HOPE CREEK GENERATING STATION  
DOCKET NO. 50-354  
FSAR COMMITMENT STATUS THROUGH AUGUST 1984

ATTACHMENT I  
HOPE CREEK GENERATING STATION  
FSAR COMMITMENT STATUS THROUGH AUGUST 1984

QUESTION 220.21 (SECTION 3.7.2)

FIGURE 210.21-28  
 RESPONSE SPECTRA COMPARISON,  
 AUXILIARY BUILDING AT ELEV. 54' -0",  
 E-W, OBE, 2% DAMPING

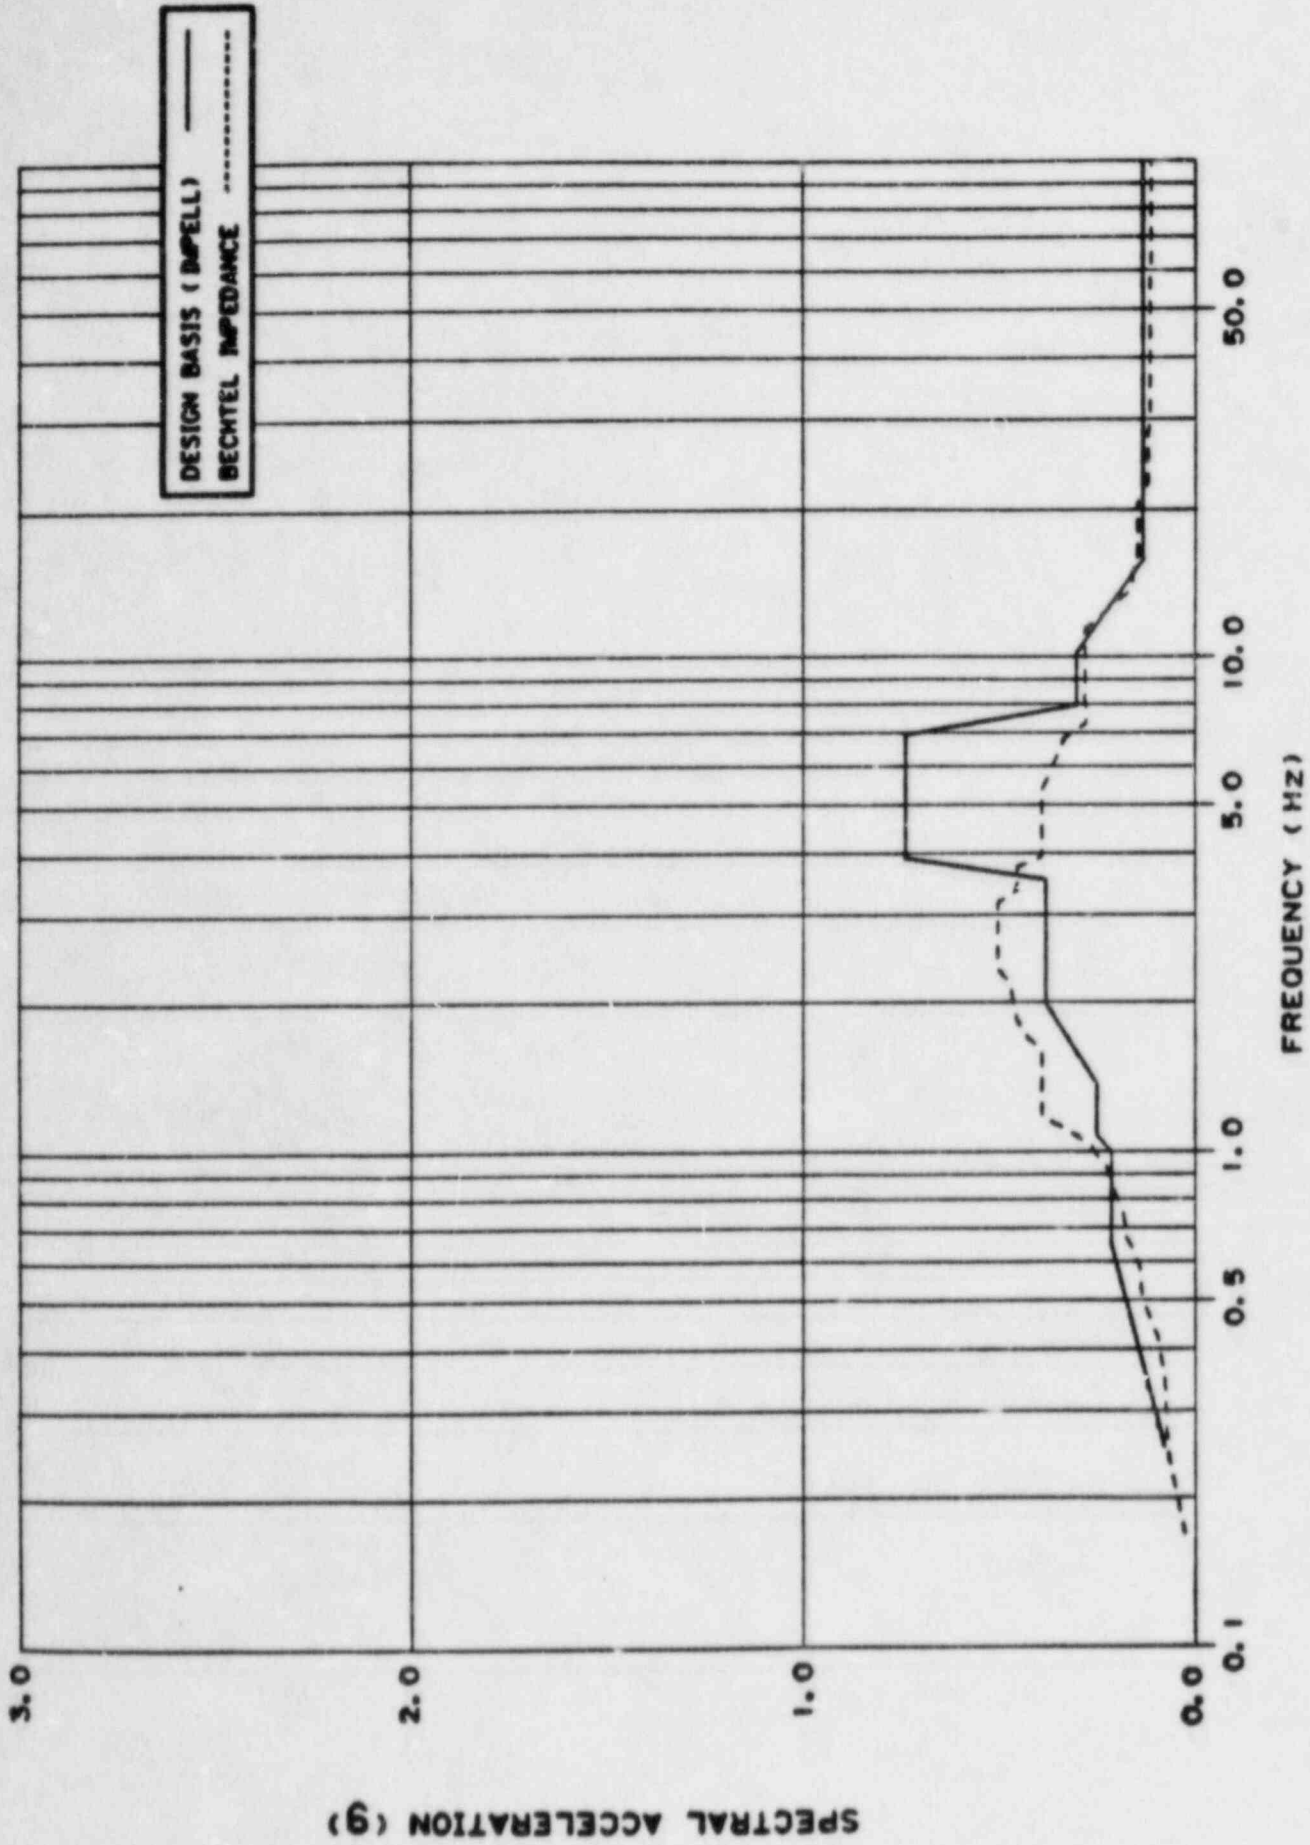
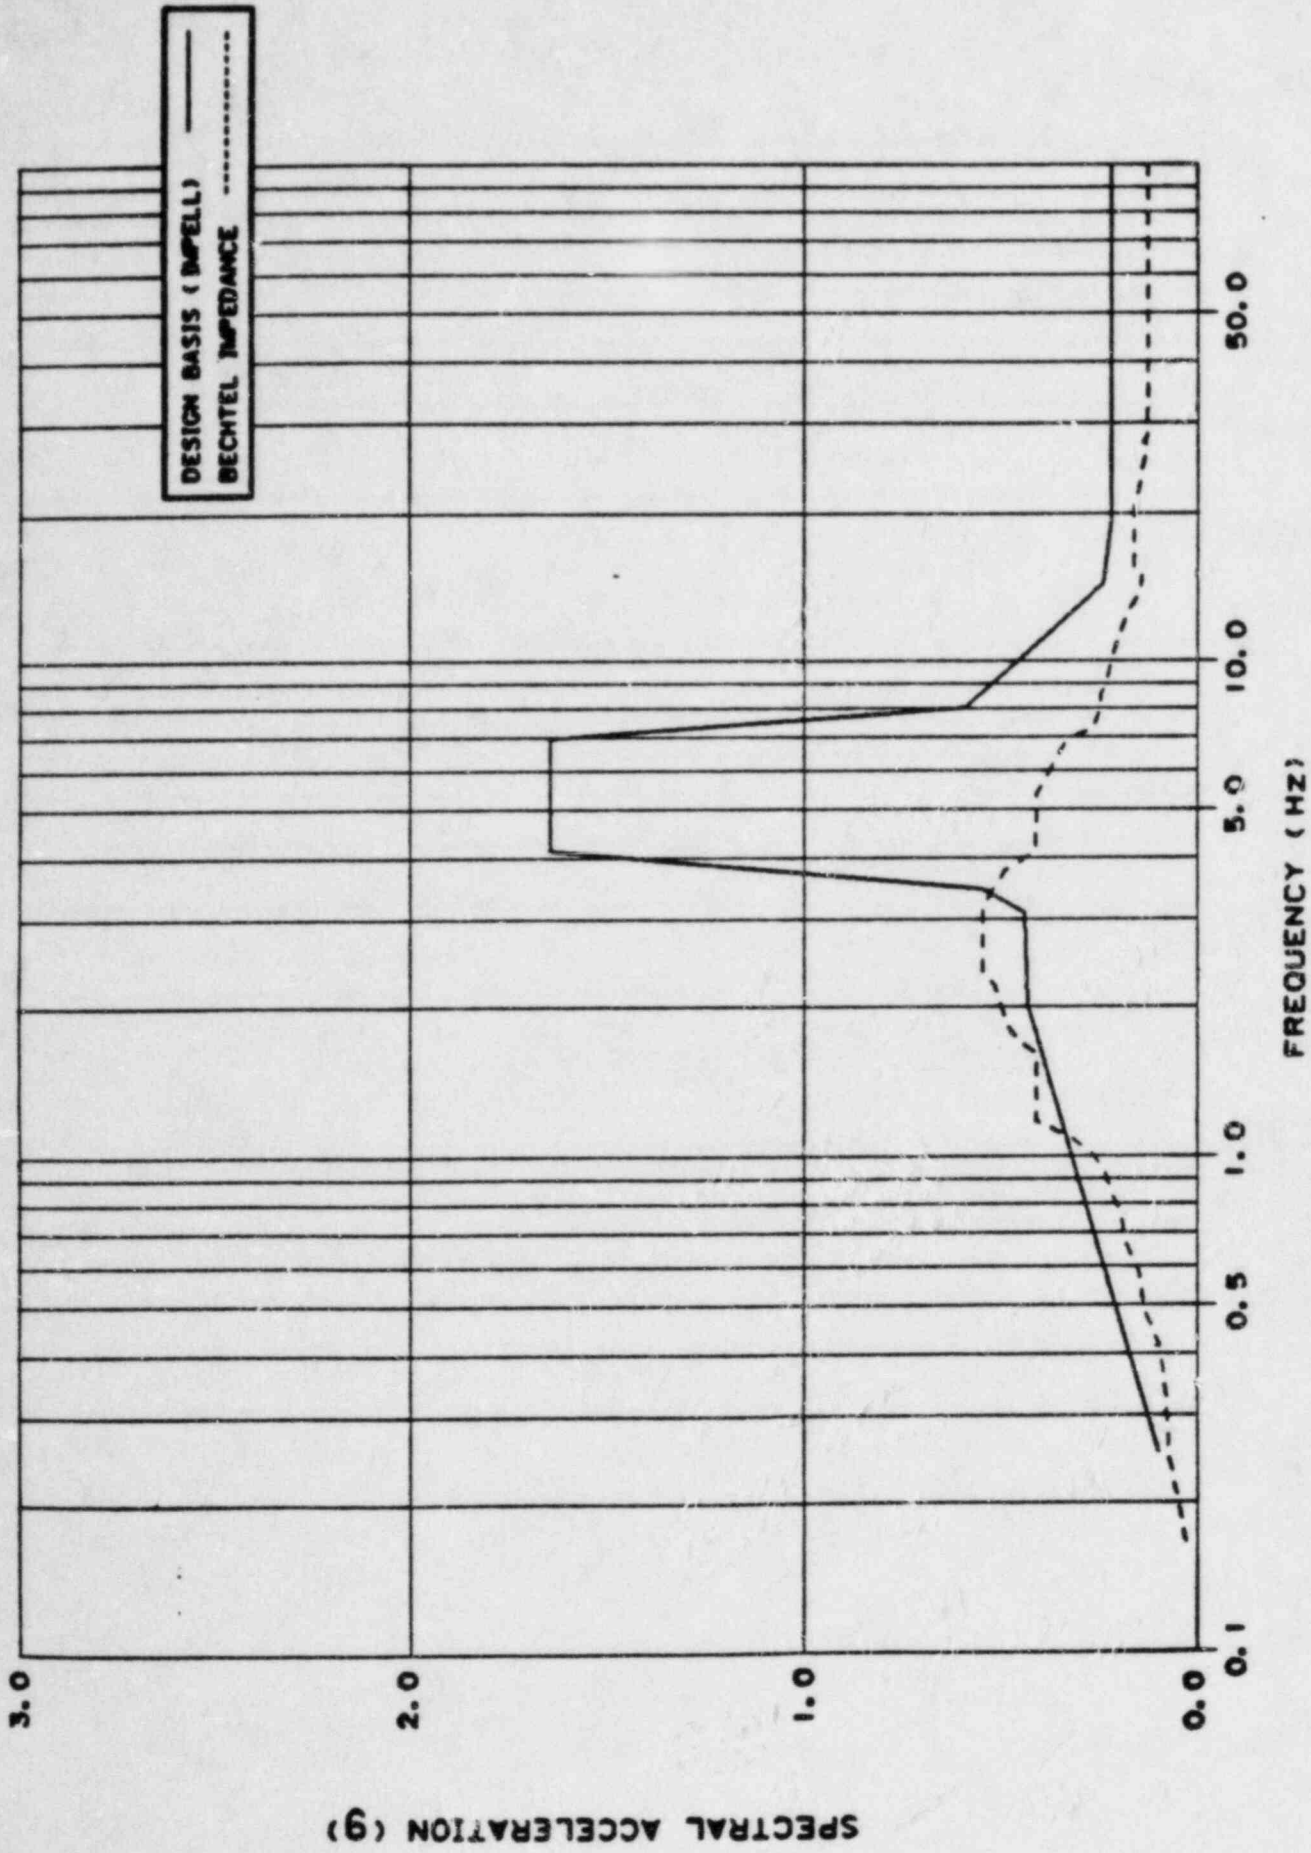
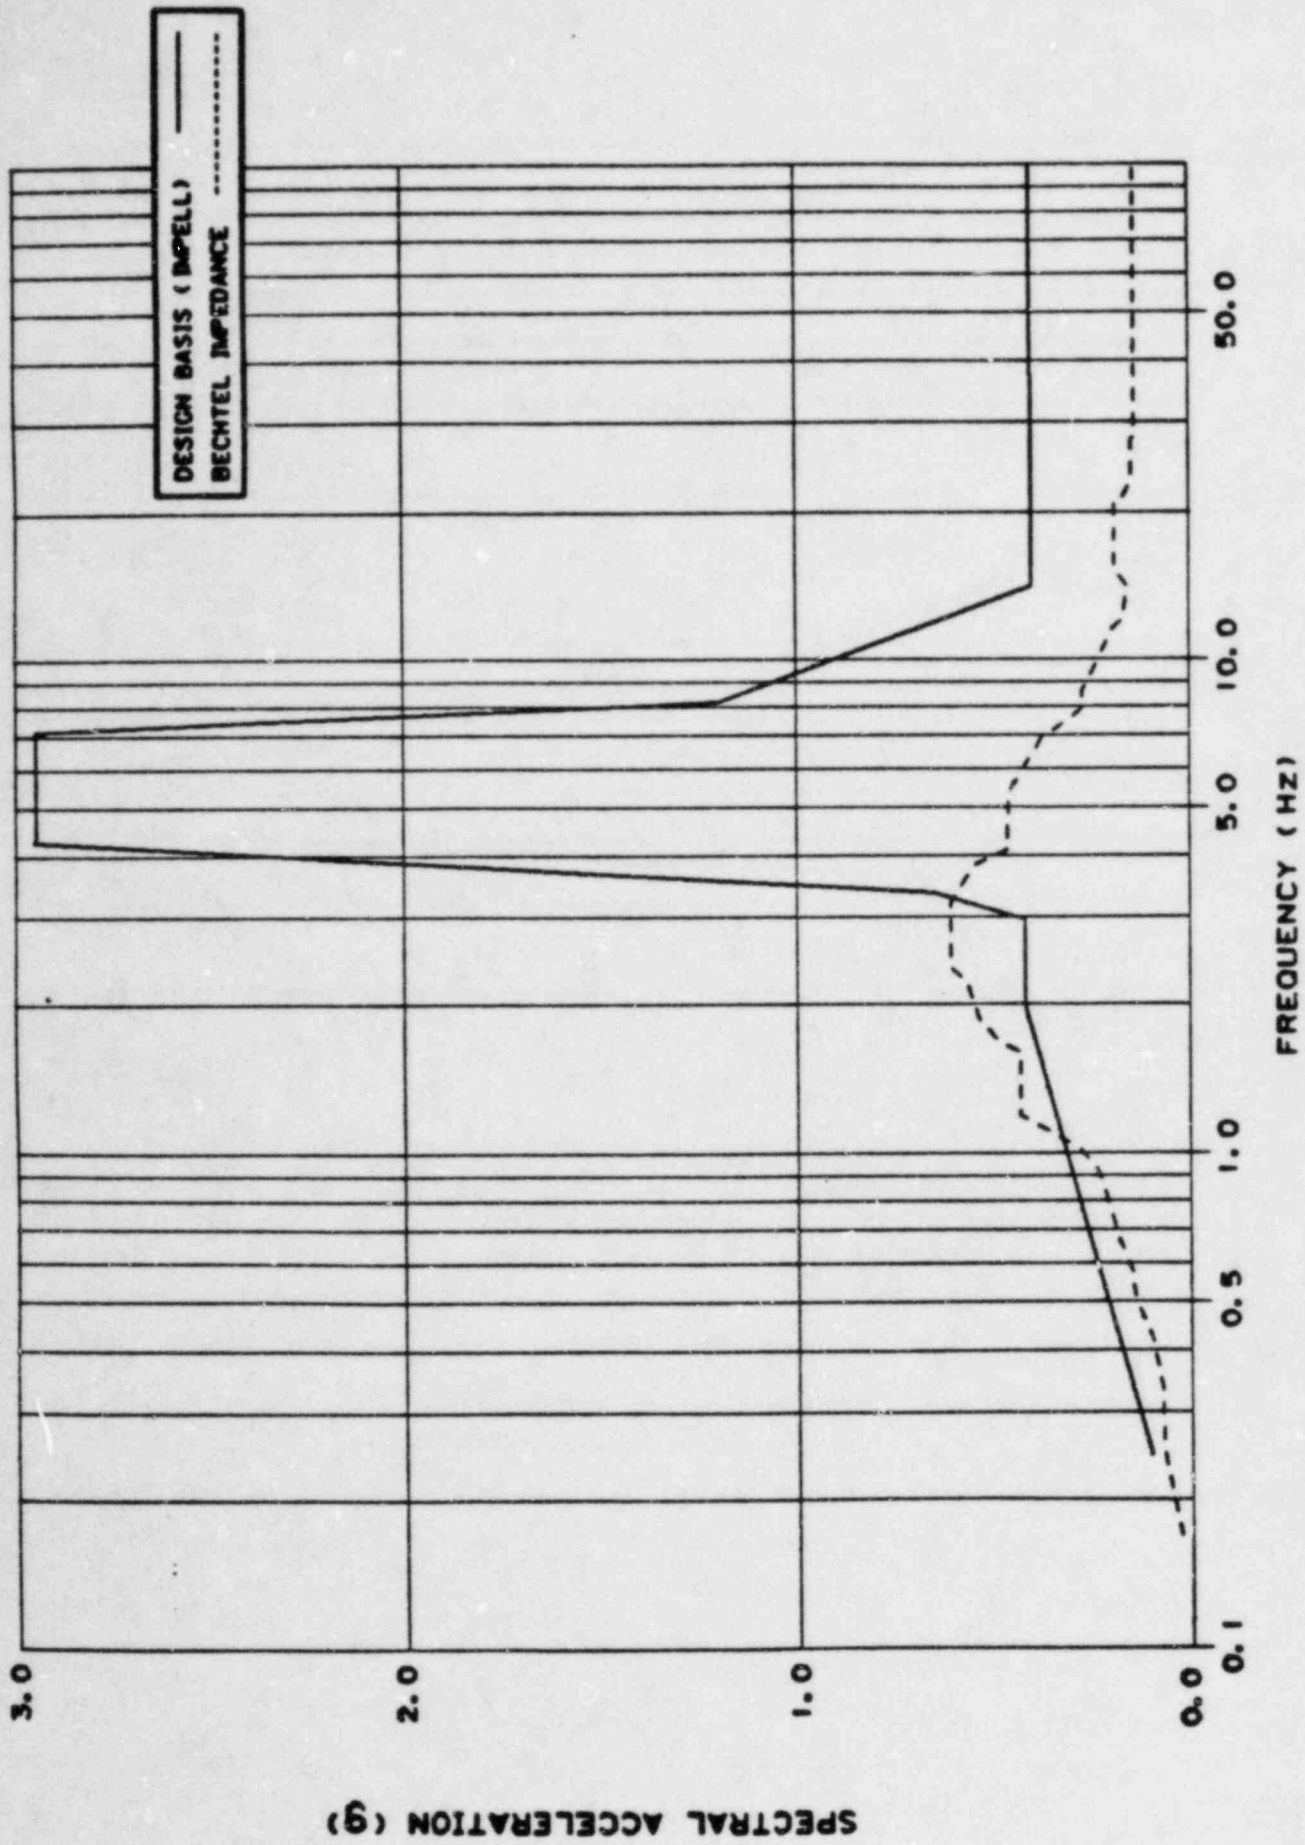
The Hope Creek soil-structure interaction analysis is performed by applying a specified earthquake input motion at the base of the finite-element model. The base level input motion is generated through a deconvolution analysis. The applicable SRP criteria for soil-structure interaction analysis require that both the half-space and finite-element approaches should be considered. (For details refer to SRP 3.7.2-11.4). Public Service should perform necessary analyses to demonstrate conformance to the criteria.

Figures 220.21-1 through 220.21-54 show a comparison of the 2 percent damping response spectra obtained from the design basis finite element and the impedance analyses for the reactor building, auxiliary building and the service water intake structure (SWIS).

¶ For the reactor and auxiliary buildings, the peak spectral accelerations obtained from the impedance analysis are generally lower than those obtained from the design basis analysis. However, the impedance analysis response spectra are not completely enveloped by those obtained from the design basis analysis, especially in the frequency range from 1.0 to 3.5 Hz. Also, there are some local exceedances in the higher frequency range, as shown in Figures 220.21-1 through 220.21-36. ¶ For the SWIS (Figures 220.21-37 through 220.21-54), the impedance analysis response spectra are generally enveloped by those obtained from the design basis analysis at elevation 114.0 feet. For other elevations, the impedance analysis spectral accelerations exceed the design basis spectral accelerations in some frequency ranges. These ranges vary approximately between 1.5 and 10.0 Hz.

forces and moments obtained from the impedance analysis exceeded the design basis values at various locations within these buildings. The auxiliary building seismic shear forces and moments obtained from the impedance analysis are less than the design basis shears and moments.

Since the impedance analysis results are not completely enveloped by the design basis finite element analysis results, sampling studies are conducted to confirm the adequacy of the plant design. These sampling studies include an evaluation of the following items:

In all cases, the items reviewed during these sampling studies can accommodate the loads resulting from the impedance analysis. Therefore, the impedance analysis results have no impact on the plant design.
